Service Bulletin No. 397B

<i>MODEL</i> D Series	<i>TYPE</i> Field Change Program	<i>SECTION/GROUP</i> 8-Engine	<i>DATE</i> June 13, 2017
<i>SUBJECT</i> EXHAUST SYSTEM BELLOWS PIPE			
<i>CONDITIONS</i>

SERVICE BULLETIN 397 WAS REVISED TO REFLECT ADDITIONAL D SERIES COACHES AFFECTED BY THIS REWORK

Ref. NHTSA Recall No.:17V-337 (REISSUANCE OF 13V-142)

Figure 1. Exhaust system bellows pipe.

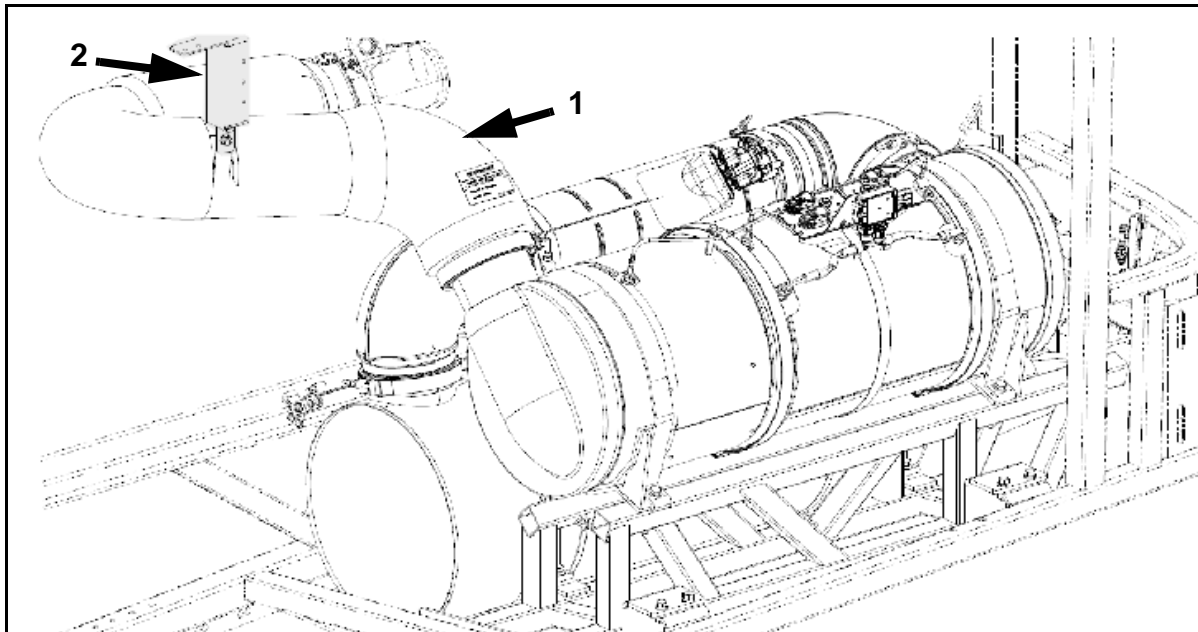
4. Remove and retain the blanket on the turbo side of the installation, and place the blanket on a workbench.
5. Locate and remove the existing two (2) capscrews and locknuts from the pipe assembly bracket where it attaches to the coach frame (refer to Figure 1). Remove and retain the mounting hardware to be re-installed at a later step in this procedure. Discard the existing pipe assembly bracket.

11. Locate the pipe assembly bracket where it attaches to the coach frame (refer to Figure 8).
12. Using the mounting hardware removed in Step 5. and new bracket, p/n 08-20-2350, secure the bracket to the coach frame. Torque to 33-37 ft-lbs.

Figure 4.

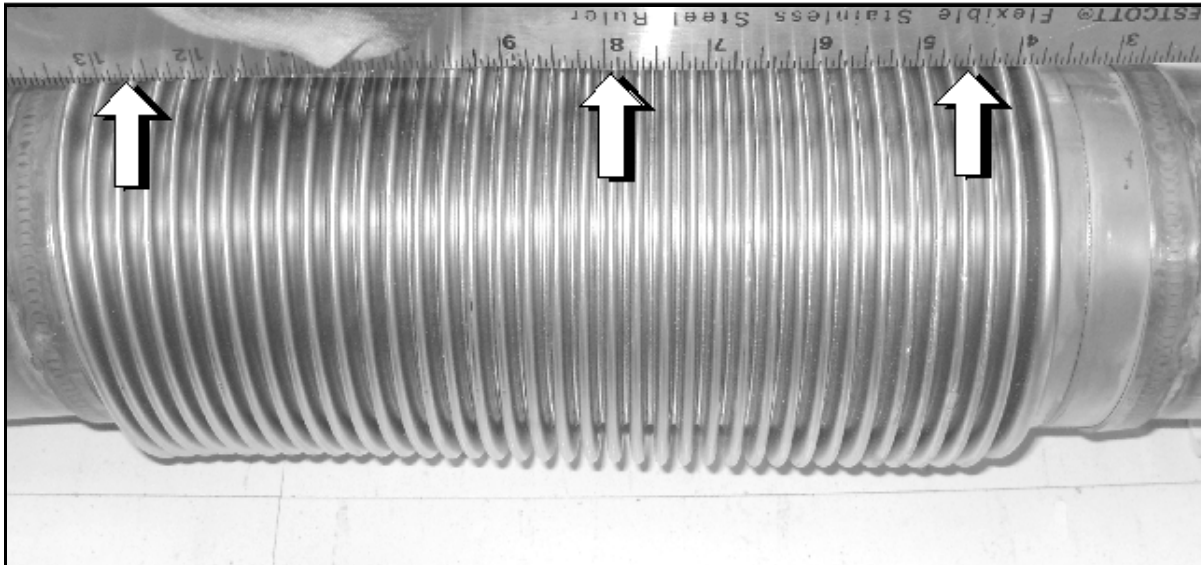
3. the bellows pipe has a gap of more than 0.250 inch between a straight edge and the bellows due to permanent deformation, when a straight edge is positioned over the bellows at multiple positions around the circumference (refer to Figure 4).

If any one (1) of the above three (3) conditions exists, a new bellows pipe, p/n 08-20-1786, is required to be installed in Step 8. of this procedure.

Figure 6.

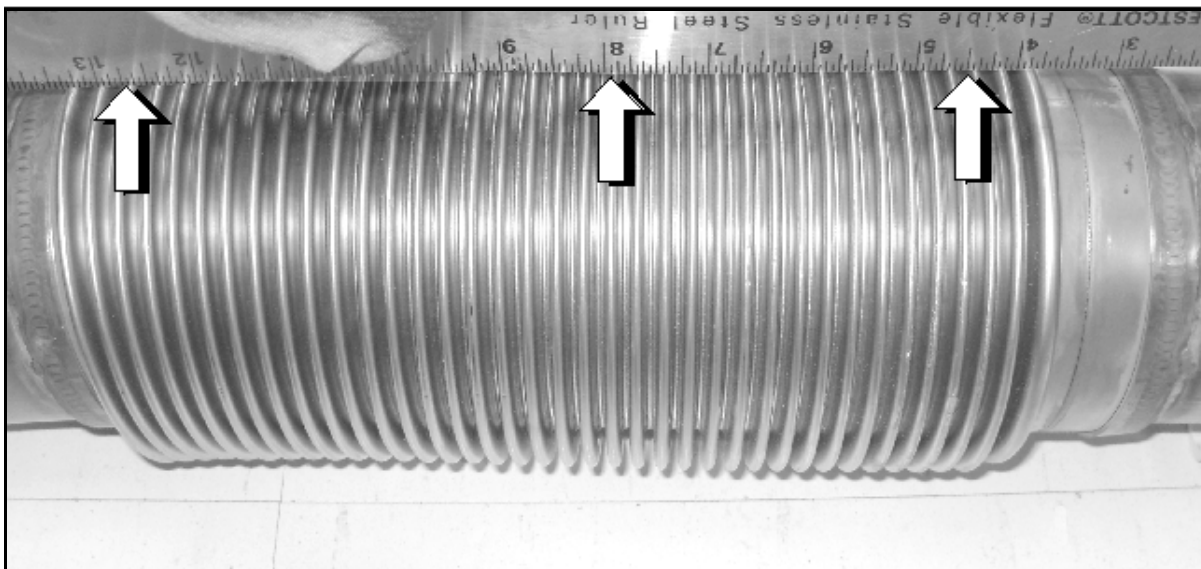
9. Position a straight edge over the bellows at multiple positions around the circumference to ensure there is no deformation or gaps (refer to Figure 6) prior to tightening the clamps. Orient as required to achieve no deformation or gaps.

Figure 7.

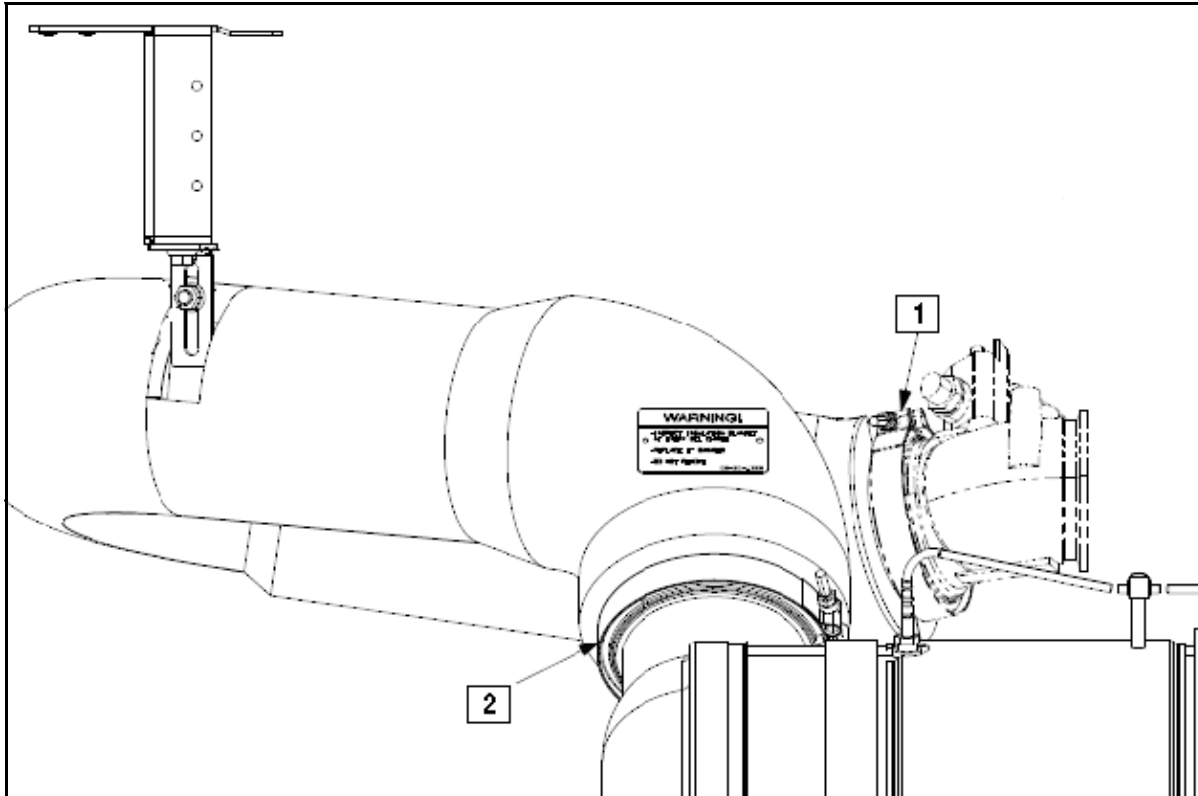
10. Orient the exhaust pipe seat, and tighten the clamps to the exhaust pipe per the following steps:
 - a. Torque the clamp, Item 1 in Figure 8, to 86-95 in-lbs. Torque the clamp, Item 2 in Figure 8, to 100-110 in-lbs.
 - b. Tap around the clamps in three (3) places with a rubber mallet,
 - c. Re-torque the clamps,
 - d. Tap around the clamps in three (3) places with a rubber mallet,
 - e. Re-torque the clamps.

Item	Description
1	Torque to 86-95 in-lbs
2	Torque to 100-110 in-lbs
